**OPUS AT SYRACUSE
SUBDIVISION
PRELIMINARY PLAN**

RE: **Opus at Syracuse**
Project Site Review PR-22-24
1030-60 Genesee St E & University
Syracuse, NY 13210

Below please see our written response to the Opus at Syracuse review dated 02/02/23. We have duplicated the original review comments and followed with our response in *italic bold type*.

2 SITE PLAN
PP0.3 SCALE: 1/16" = 1'-0"

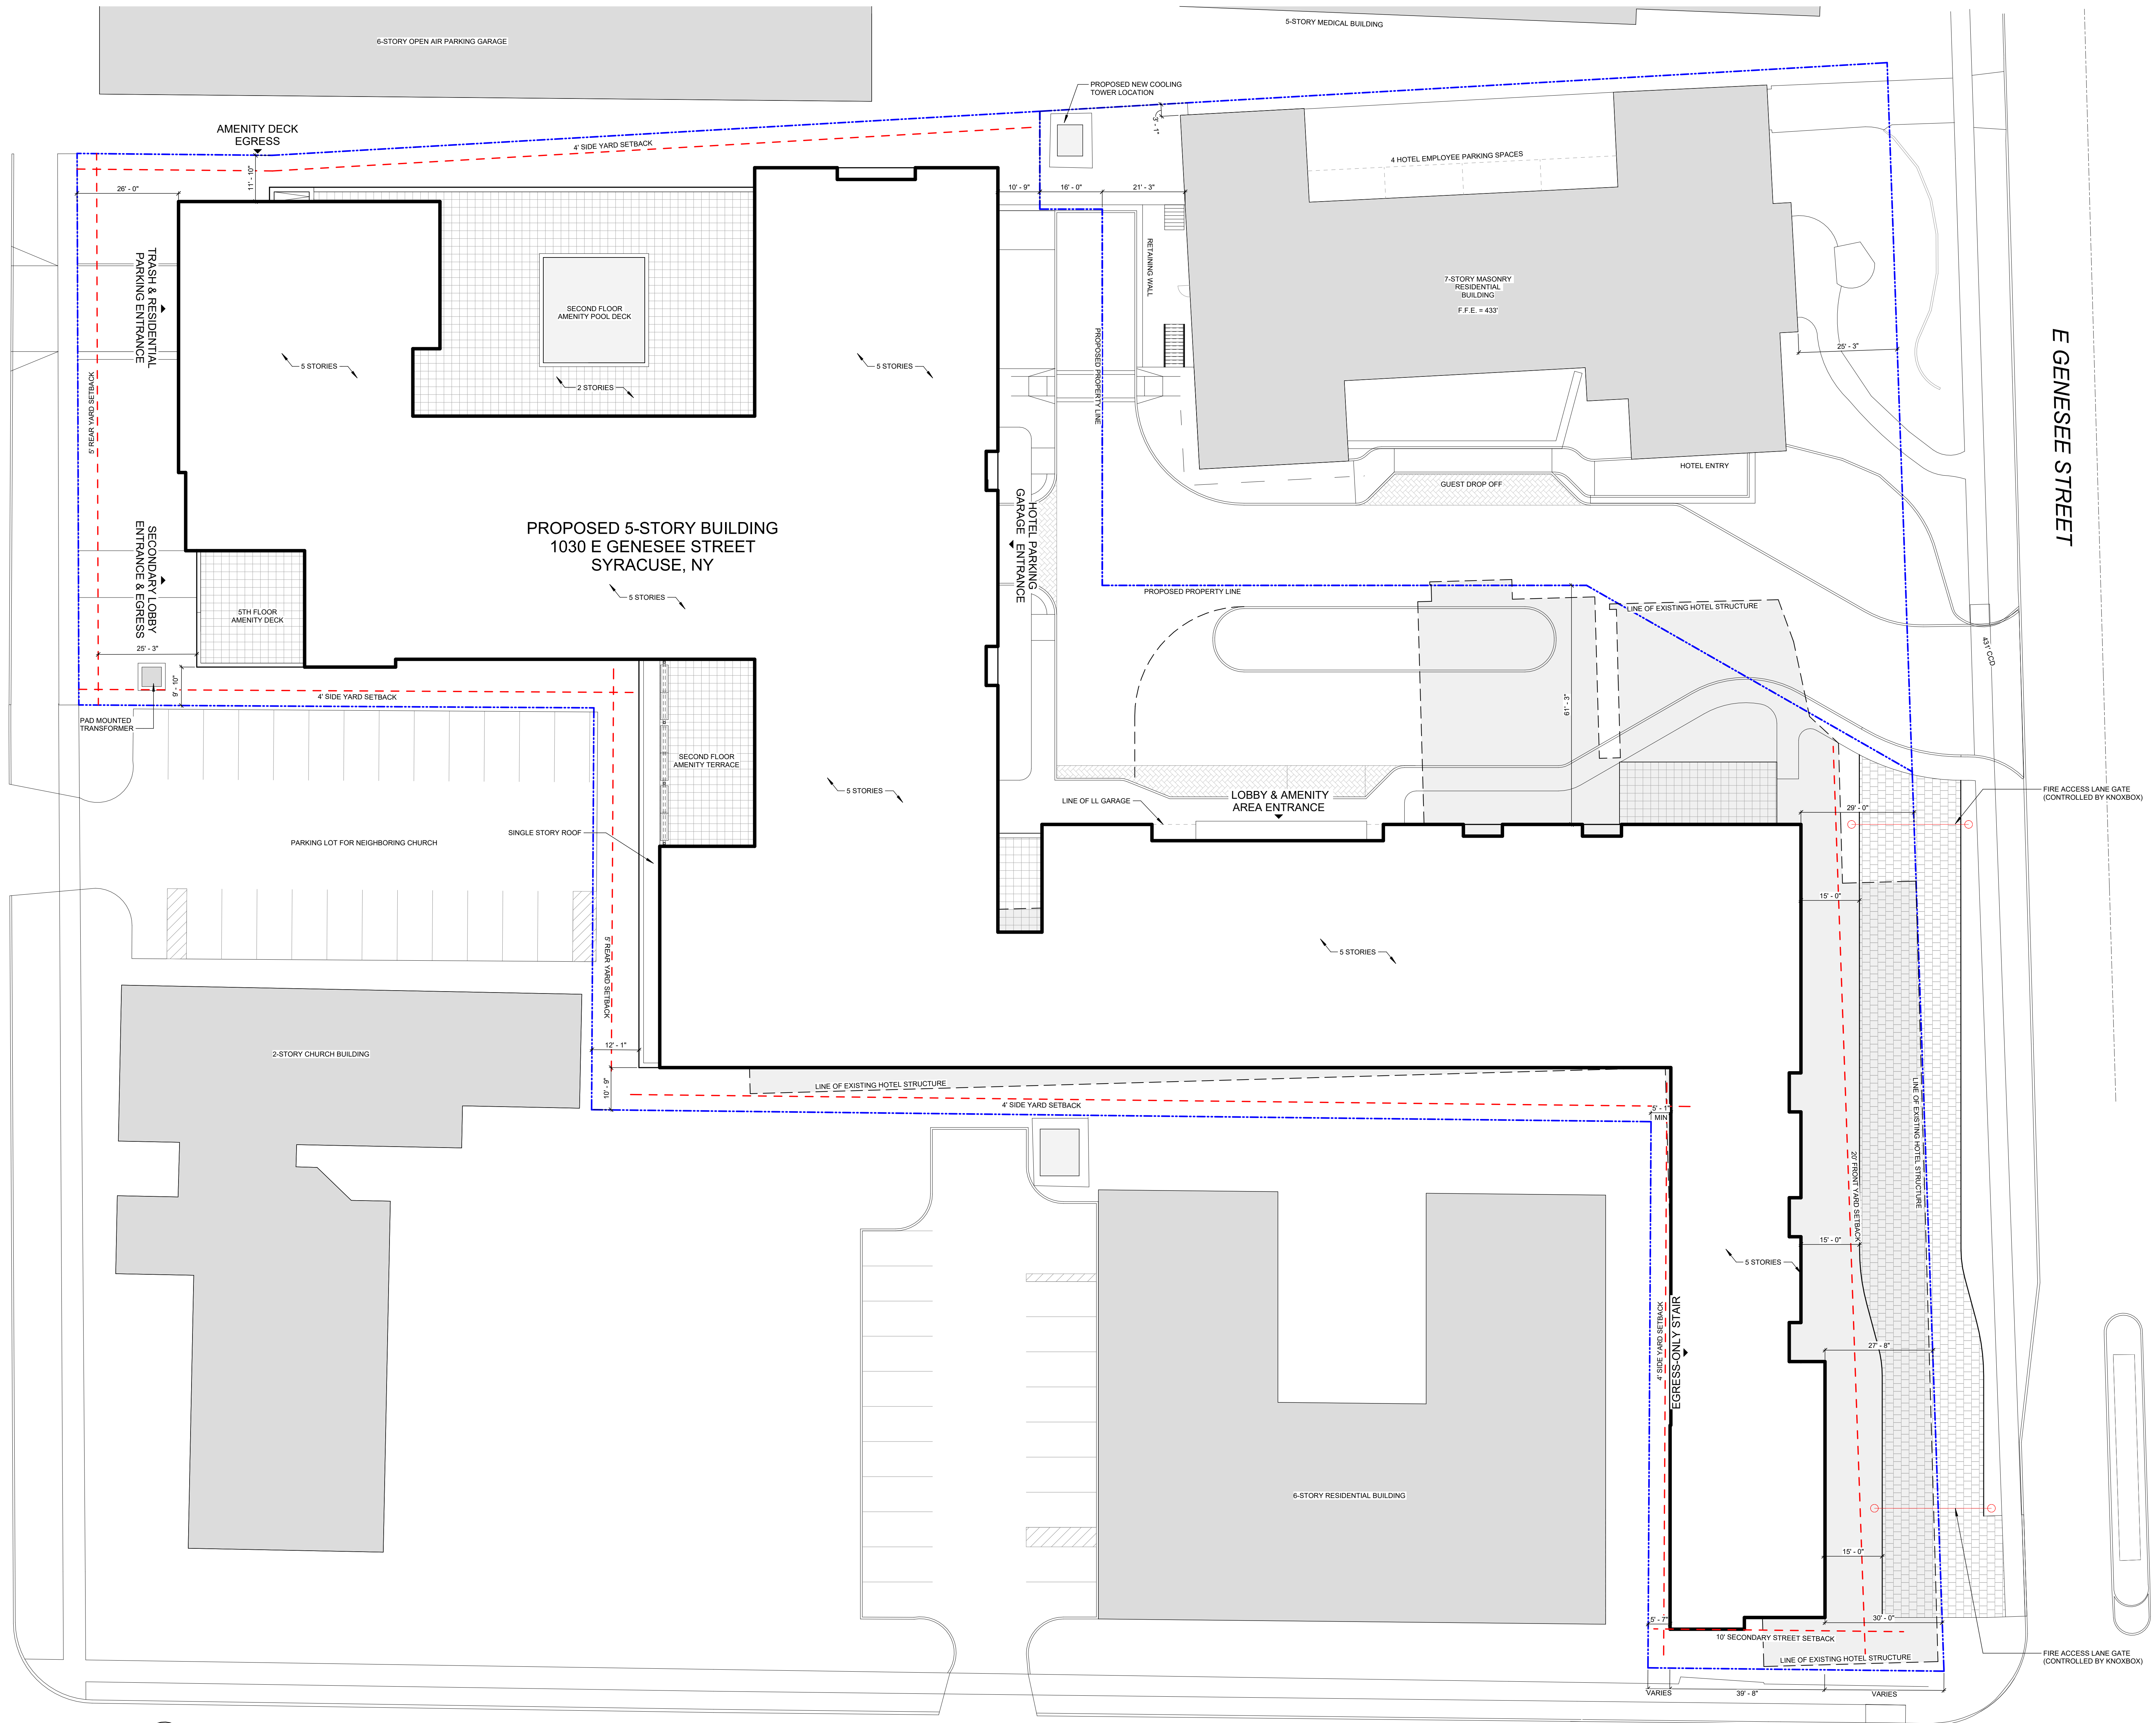
- Fire Access lane proposed along Genesee Street produces incongruous streetscape and requires revision.
- Fire Access lane to be accommodated on site, outside of ROW, and include access controls to prevent errant parking/loading etc, signage is not sufficient. If Fire Access lane cannot be accommodated on site the proposed building layout is to be changed. Fire Access lane cannot make use of ADA corner curb ramps.

- ADA compliant leadwalks required on both sides of drop off loop. 6'+ wide (to accommodate snow storage) around loop area with raised curb or bollard to prevent errant parking/overhang/obstruction of lead walks,

- Leadwalks to provide continuous loop around drop off area, including additional crosswalk(s) at garage opening(s)

- Single direction opening to garage along Madison St to be 12' max width. Opening to conform to NYSDOT Type 3 entrance spec, no radial curb, driveway to be curbed.

Proposed Aerial Fire Apparatus Access Road along E Genesee Street does not meet Section D105.2 of the 20209 Fire Code of NYS. The 26' width requirement should be continuous and unobstructed in the immediate vicinity of that portion of the building. The width is reduced to less than 26' in one area. Plans do not document the setback distance from the face of the building to the proposed access lane for its entirety.

Response: Building wing facing Genesee Street has been modified to create a separate and dedicate sidewalk and fire lane. The fire lane has been moved south to the greatest extent possible. These two areas are separated by a planting area that runs the length of Genesee Street. The fire lane includes a gate at each end, controlled by a knoxbox to prevent errant parking/loading. The fire access point will be accessed by a mountable curb at the east end of Genesee Street. The fire lane will not make use of the existing ADA corner curb ramp. (See Sheet C-101 & PP0.3.)

Response: An ADA compliant 6ft wide leadwalk with raised curb extends around the drop off loop. A leadwalk has been provided on the east side of the driveway for the proposed project extending from Genesee Street to the building entrance. This leadwalk has been increased to 6ft wide. An existing leadwalk currently serves the Mayflower from the Genesee Street sidewalk. (See Sheet C-101 & PP0.3)

Response: A continuous leadwalk loop has been provided around the drop off area and a crosswalk has been provided at the garage opening. (See Sheet C-101 & PP0.3)

Response: The vehicle entrance along Madison supports two-way traffic. The minimum width drive of 22' has been provided. Opening to conform to NYSDOT Type 3 entrance spec. As an added note, this design removes and existing curbcut along Madison, improving pedestrian safety. (See Sheet C-101 & PP0.3)

Response: Plans have been modified to create a continuous 26' wide fire access lane. Dimensions have been added to the plan to confirm that the 15' minimum distance from building to fire access lane and 26' fire access lane is consistent for the entire length of the lane. Per direction from DPW – Transportation, a gate has been added to each end of the fire lane. The gate will be controlled by a knoxbox. (See Sheet C-101 & PP0-3)
